# UNITED STATES PATENT AND TRADEMARK OFFICE

APPLICATION NO.	FILING DATE	FIRST NAMED INVENTOR	ATTORNEY DOCKET NO.	CONFIRMATION NO.
10/737,265	12/15/2003	Jean-Pierre Steiner	P/3328-63	5796

**Office Action Summary**

## **DETAILED ACTION**

Newell, 2,260,048

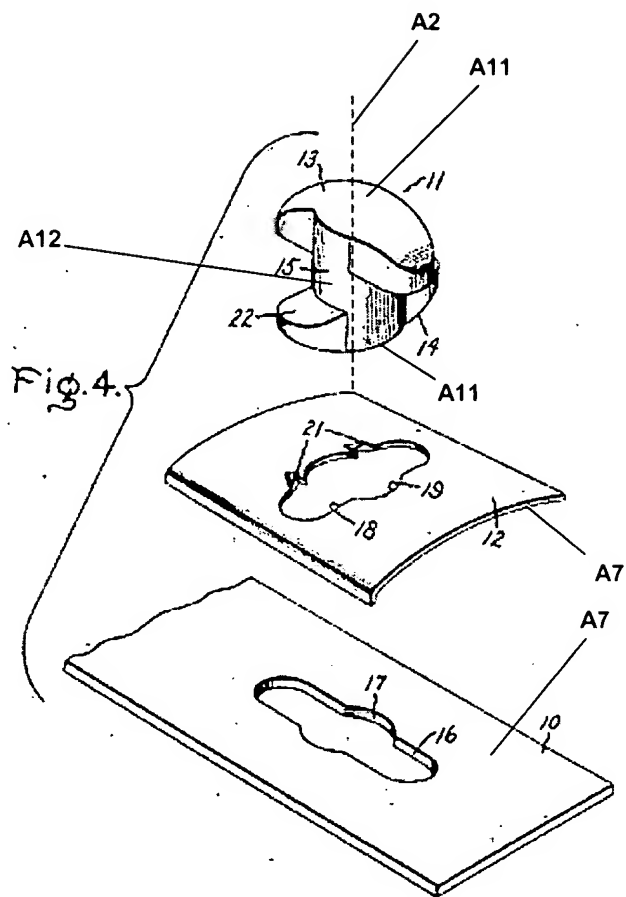
Regarding claim 1, as best understood, Newell discloses, in Figure 4, an assembly member comprising a first flat tool **10**, a second flat tool **12**, and a cylindrical unit **15** having a rotating axis **A2**. The cylindrical unit **15** includes elements **13,14**.

Regarding claim 4, wing passage openings **16-19** are in the first flat tool **10** and the second flat tool **12**. The openings **16-19** are shaped so that the wings **13,14** fit without clearance through the openings **16-19**. The wings **13,14** are offset from the openings **16-19** and no longer pas through the openings **16-19**.

Regarding claim 5, the cylindrical unit **15** has opposite ends **A11** and the wings **13,14** are respective toward each of the opposite ends **A11** of the cylindrical unit **15**.

Regarding claim 6, the wings **13,14** are arranged in pairs thereof. The openings **16-19** are arranged in correspondingly shaped pairs.

Hayes et al., 5,620,291

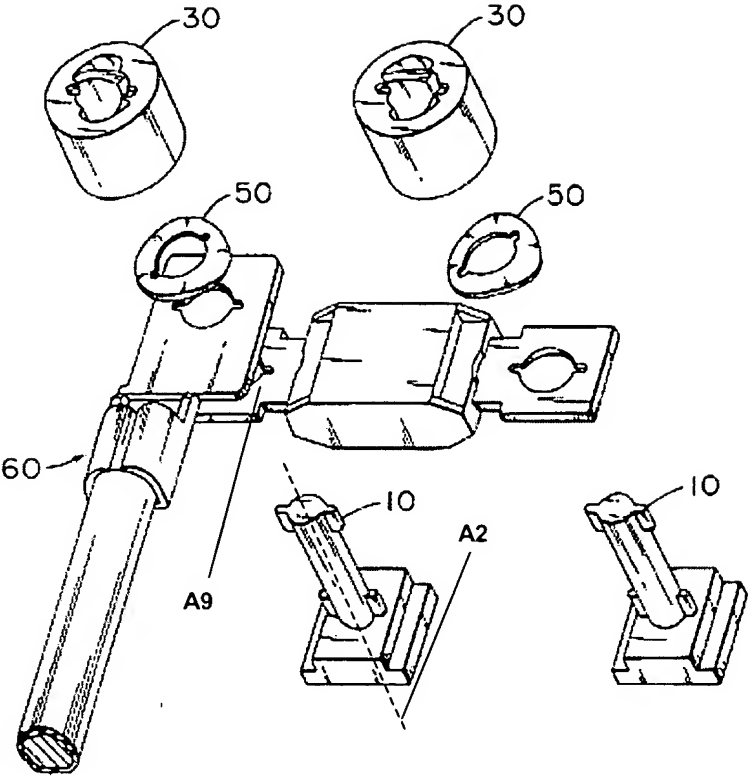
Regarding claim 1, as best understood, Hayes discloses, in Figure 6, an assembly member comprising a first flat tool **30**, a second flat tool **A9**, and a cylindrical unit **14** having a rotating axis **A2**. The cylindrical unit **14** includes elements **22,25**.

Regarding claim 8, a gripping profile **12** is at least at one end **16** of the cylindrical unit **14** and shaped to facilitate revolution of the cylindrical unit **14** around the rotating axis **A2**.

Regarding claim 9, the gripping profile **12** includes a profile defined inside the cylindrical unit **14** or a profile defined on the outside of the cylindrical unit **14**.

Regarding claim 10, at one end **16** of the assembly is a head and the gripping profile **12** is defined at the head.
